PCI-SIG ENGINEERING CHANGE NOTICE

TITLE:	Hierarchy ID Message
DATE:	Introduced: Feb 23, 2016 Updated: Sept 8, 2016 14-day Cross WG Review: Sept 15, 2016 Member Review: October 20, 2016 Final Approval: February 22, 2017
AFFECTED DOCUMENT:	PCI Express Base Specification, Version 3.1a Single Root I/O Virtualization and Sharing Specification, Revision 1.1 PCI Code and ID Assignment Specification, Version 1.7
SPONSOR:	Steve Glaser, Nvidia

2.2.8.6.5 Hierarchy ID Message

Figure 2-xx: Hierarchy ID Message

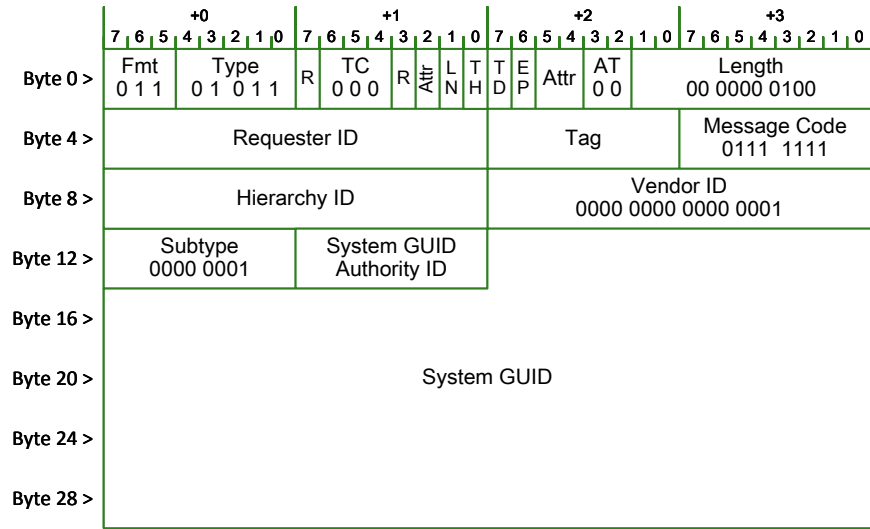
Hierarchy ID uses the PCI-SIG-Defined VDM mechanism (see Section 2.2.8.6.1). The Hierarchy ID Message is a PCI-SIG-Defined VDM (Vendor-Defined Type 1 Message) with payload (MsgD).

- Table 2-xx and Figure 2-xx illustrate and define the Hierarchy ID Message.
- The TLP Type must be MsgD.
- Each Message must include a 4-DWORD data payload.
- The Length field must be 4.
- The TC[2:0] field must be 000b.
- The Attr[2:0] field is Reserved.
- The Tag field is Reserved.
- The Subtype field is 01h.
- The Message Routing field must be 011b – Broadcast from Root Complex.

The payload of each Hierarchy ID Message contains the lower 128-bits of the System GUID.

Figure 7-x1: Hierarchy ID Extended Capability

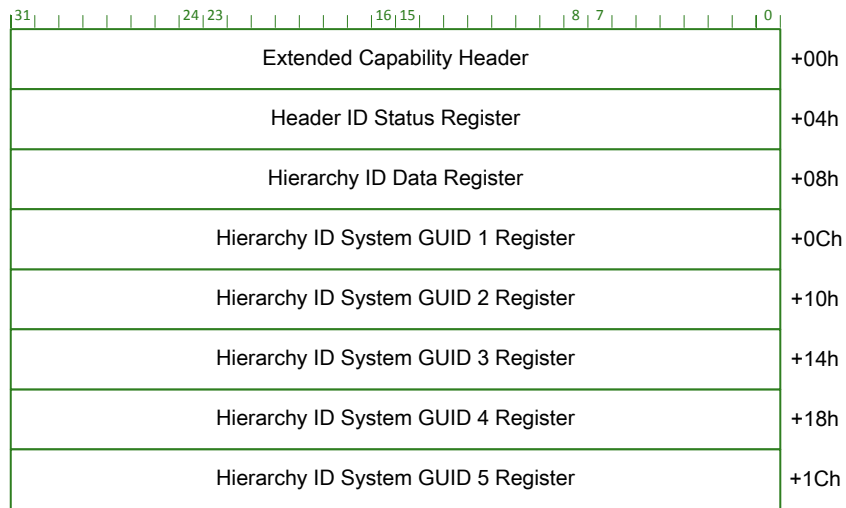
The Hierarchy ID Extended Capability provides an optional mechanism for passing a unique identifier to Functions within a Hierarchy. At most one instance of this capability is permitted in a Function. This capability is not applicable to Bridges, Root Complex Event Collectors, and RCRBs.

Figure 7-x1 details the layout of the Hierarchy ID Extended Capability.

Figure 7-x3: Hierarchy ID Status Register

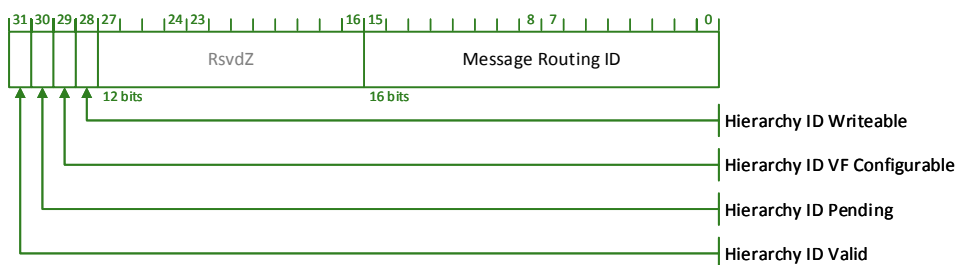
Figure 7-x3 and Table 7-x3 detail allocation of fields in the Hierarchy ID Status Register.

Bit Location	Description	Attributes
15:0	Message Routing ID – In an Upstream Port, this field contains the Routing ID from the most recently received Hierarchy ID Message. This field is meaningful only if Hierarchy ID Valid is 1b. In a Downstream Port, this field is RsvdZ. For Root Complex Integrated Endpoints, this field is RsvdZ. This field defaults to 0000h.	RO/RsvdZ
29:16	RsvdZ	RsvdZ
28	Hierarchy ID Writeable – This bit is Set to indicate that the Hierarchy ID Data and GUID registers are read/write. This bit is Clear to indicate that the Hierarchy ID and GUID registers are read only. In Downstream Ports this bit is hardwired to 1b. In Upstream Ports, Functions that are not VFs must hardwire this bit to 0b. Root Complex Integrated Endpoints that are not VFs, must hardwire this bit to either 0b or 1b.	RW/RO
